Field Service Bulletin CNG Motion Industries Flex Hose Recall

ENP-313, Rev. A July 30, 2015

Figure 1: Side mount tank enclosure with crossover fuel hose highlighted in red.

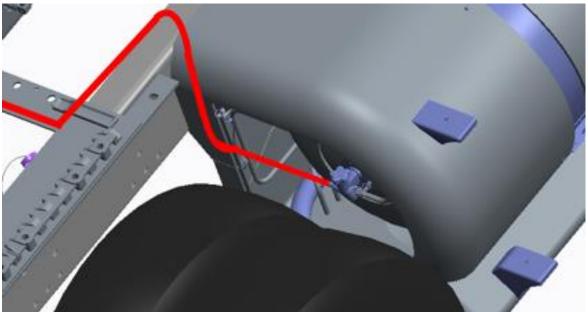
This recall targets hoses Motion Industries stainless steel braided hoses that terminate inside of a side mounted tank enclosure. These parts been observed to experience accelerated corrosion on an exposed area of braid near the collet on the end of the hose.
